**Before an Expert Panel  
Bendigo-Ophir Gold Project**

**FTAA-2507-1089**

**Matakanui Gold Limited**

**STATEMENT OF EVIDENCE OF DR LEANNE MORGAN  
GROUNDWATER HYDROLOGY**

Figure 1. Profile looking down-valley, including water table, schist zones and RAS pit floor/wall outline (B.03, figure 10).

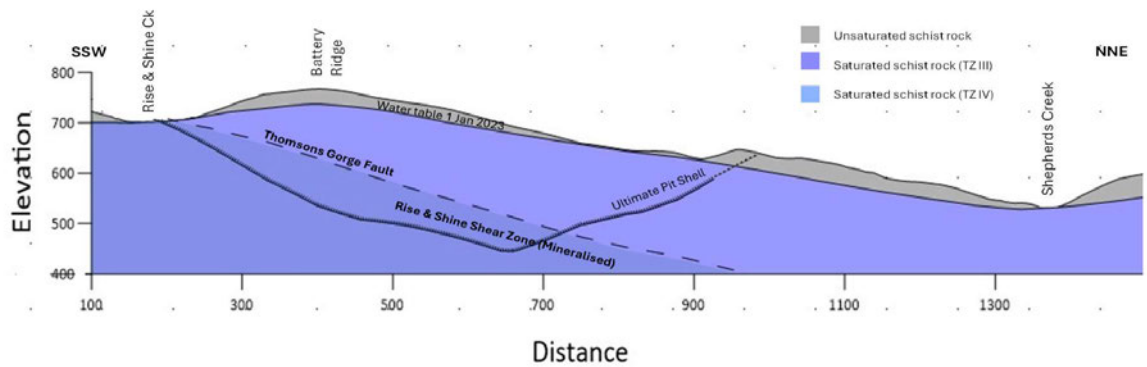
29. However, the data from 20 Jan 2023 was used to derive an inferred water table elevation which indicates that groundwater levels and flow tend to follow the topography i.e., from topographic highs to lows (e.g., toward local creeks), as shown in Figure 1.

Figure 9. Estimated area of drawdown (radius of influence) (B.42, figure 5).

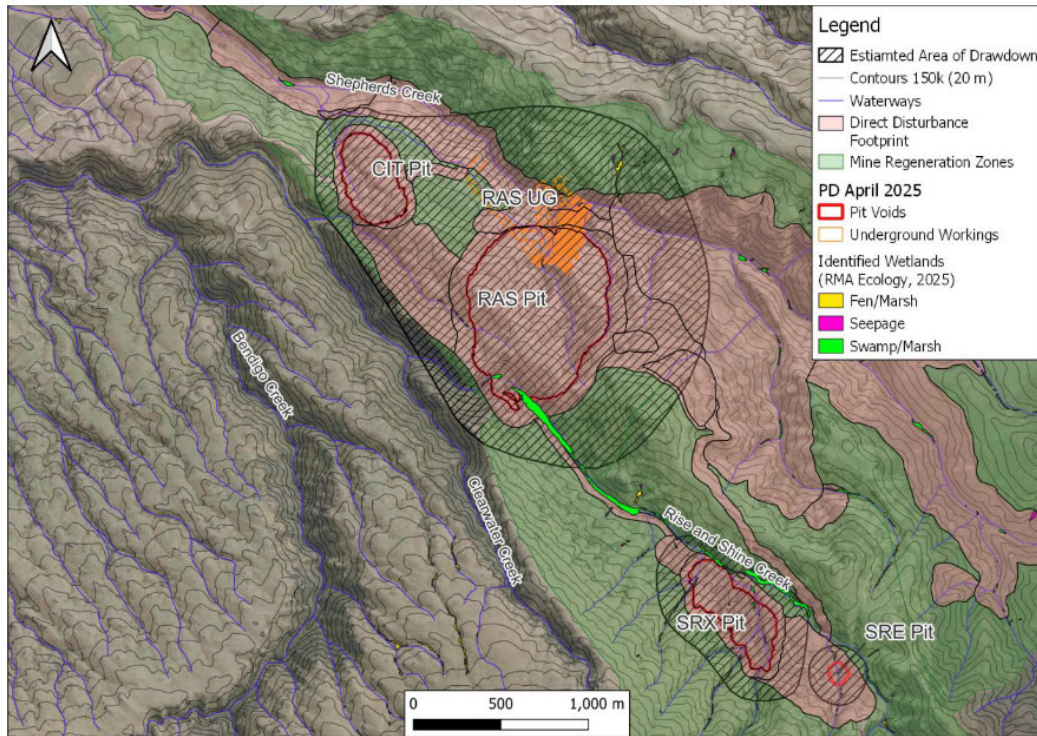
87. It is worth noting that the formula that was applied to estimate radius of influence, which originates from Bear (1979), is less conservative than others available (Bresciani et al. 2022). Also, the storativity value used in the analysis is assumed which adds uncertainty. The estimated radius of influence is, therefore, not necessarily conservative, as claimed in **B.42**.

88. The estimated radius of influence encompasses all three wetland types, as shown in Figure 9. The swamp and marsh wetlands associated with the Rise and Shine Creek make up most of the wetland area that could be impacted. This is expected given their proximity to the RAS and SRX pits. Hillslope seepage and gully fen wetlands within the drawdown areas are mainly located on the northern flank of the Shepherds Creek valley and upslope of the SRX pit on the southern flank of the Rise and Shine Creek valley.

Figure 10. SREX alluvial zone and mapped wetlands (B.05, figure 9.16)

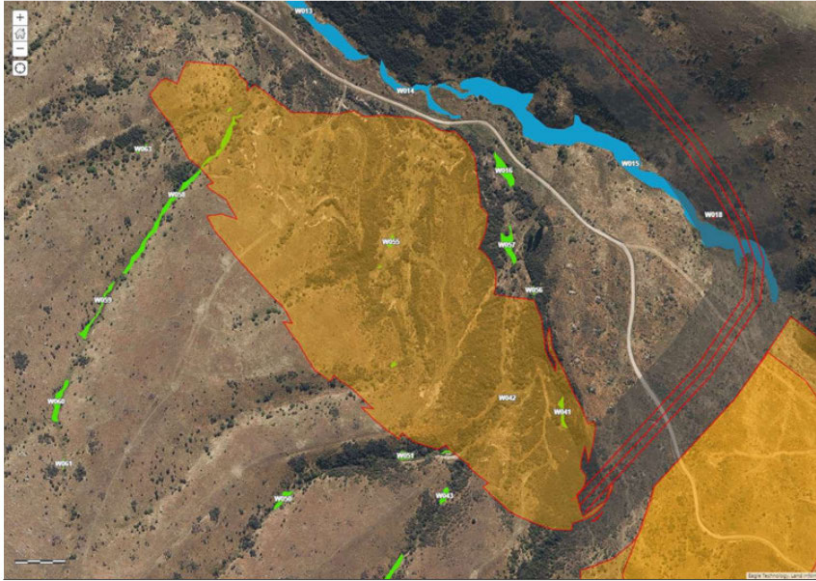
89. The groundwater modelling detailed in B.05 also found that dewatering of the SREX pit is likely to significantly impact the Rise and Shine Creek and the downstream wetlands, shown in Figure 10. The model suggests “that the most likely outcome is that the alluvial system and any nearby wetlands will be significantly impacted by the mining activities – possibly leading to the drying up of the wetlands and the loss of the alluvial system. There is not currently sufficient data to support more detailed modelling of the alluvial / SREX system, and a data campaign would be required before any further modelling could be undertaken.” As such, wetlands in the vicinity of the SREX pit will most likely be impacted and further work is needed to assess this.

Figure 11. Shepherds ELF cross-valley profile (from K.05, figure 2).

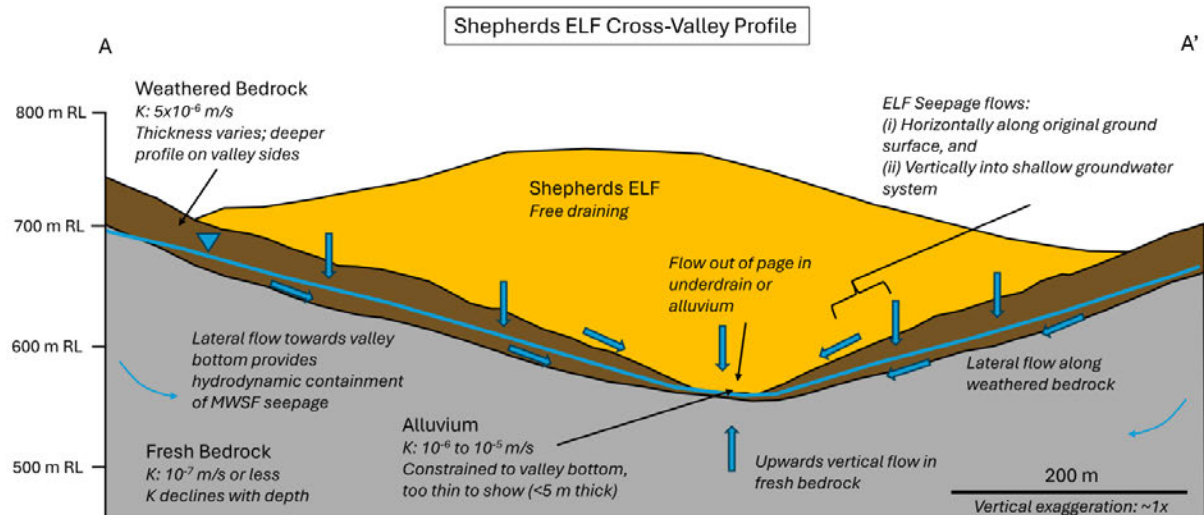
101. A central assumption of the BOGP seepage management is that topographically driven flow (i.e., groundwater flows from areas of high to low land surface elevation) will result in hydrodynamic containment within Shepherds Creek (Figure 11). As described by Smith (2021), valleys are often targeted as locations of tailings storage because if the elevation of the groundwater table along the ridges of the valley is maintained at an elevation well above the ultimate water level in the TSF, then the water in the TSF will tend to move down valley, where it can be intercepted. The assumption of hydrodynamic containment in Shepherds Creek is reasonable under current (pre-mining) conditions. However, it has also been assumed under mining and post mining conditions (**K.05**, p. 3): “During mining and post-closure, pit and underground dewatering may alter this flow pattern locally, but at the scale of the BOGP, topographically driven flow will remain the dominant condition”. This assumption needs to be rigorously tested.

103. However, Figure 11 does not include the influence of pit dewatering or tunnels on groundwater levels. The RAS pit bottom is  $\sim 450 \text{ m RL}^2$  (Figure 1) which is considerably lower than the elevation of both the TSF bottom ( $\sim 600 - 700 \text{ m RL}$ ) and the ELF bottom ( $\sim 500 - 600 \text{ m RL}$ ) (Figure 12). Therefore, groundwater levels along the southern ridge of Shepherds Creek (i.e., on the left side of Figure 11) could be below the valley floor of Shepherds Creek. This indicates considerable potential for loss of hydrodynamic containment under mining.

Figure 12. Shepherds Creek valley bottom profile (from K.05, figure 3)

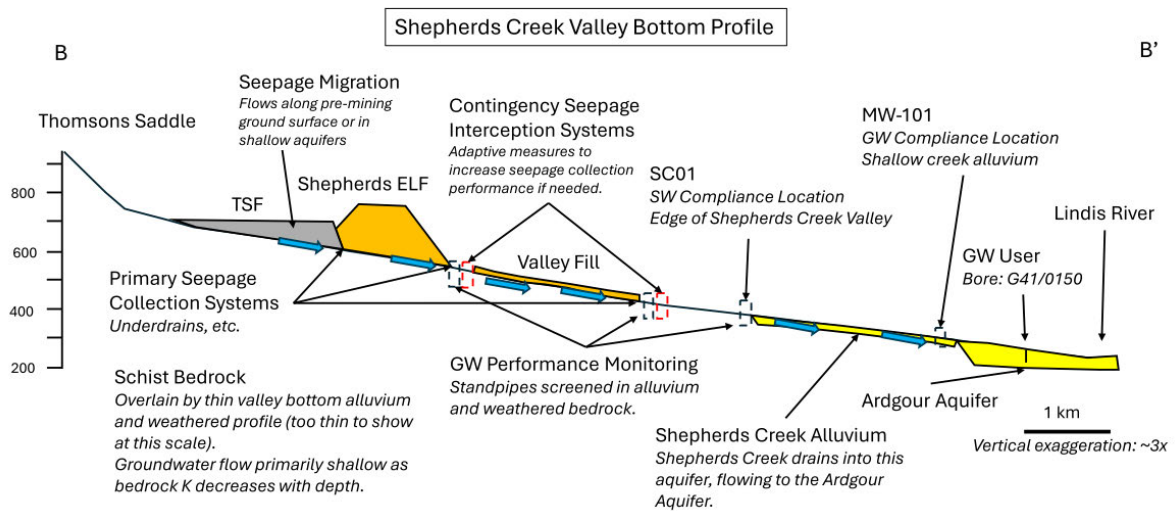
104. Additionally, the underground mining tunnels extend to a depth of ~ 150 m RL under Shepherds Creek (**G.01**) and dewatering will cause further drawdown of groundwater levels in the vicinity of Shepherds Creek increasing the potential for loss of hydrodynamic containment. The impact of tunnel dewatering on groundwater levels is unknown because it was not assessed in **B.05**.

Figure 14. Spatial distribution of maximum contaminant dilution in the Ardgour Aquifer (from K.01, figure 4.2).

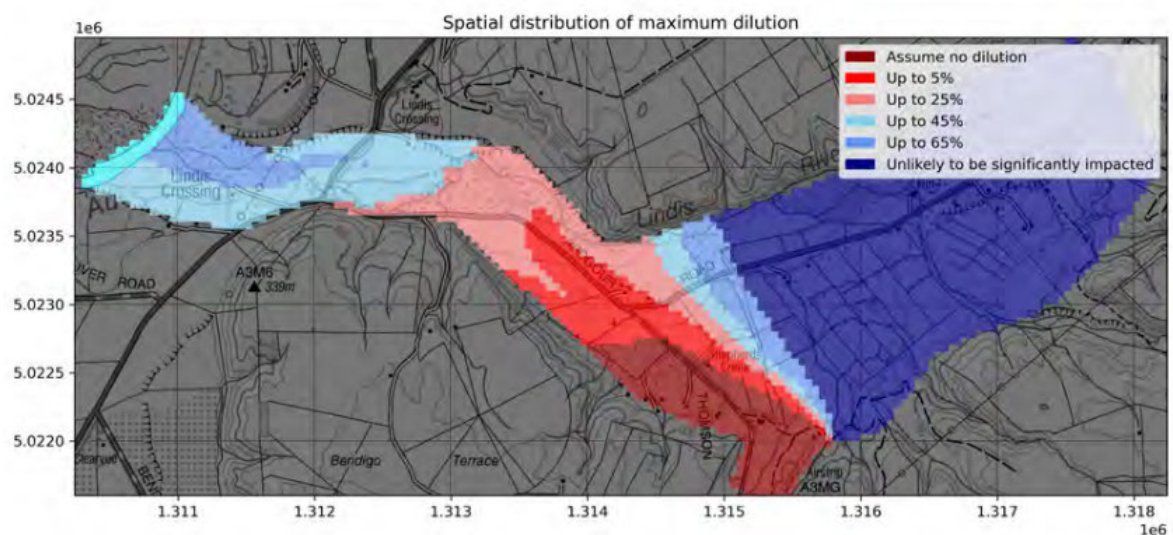
124. The key prediction of interest is the maximum dilution factor of the contaminant plume spatially in the Ardgour Aquifer (Figure 14). This shows that there is a large plume with dilution less than 50% extending to the Clutha Mata au River. Along the Lindis River this plume has dilution less than 25%. These are estimates and there is considerable uncertainty, but these results highlight the risk that unrecovered seepage of contaminants from the BOGP pose to the Ardgour Aquifer, Lindis River and Clutha Mata au River.

125. The report refers to sulphates as the contaminant of concern but there will also be a range of others including nitrogenous compounds, metals and metalloids
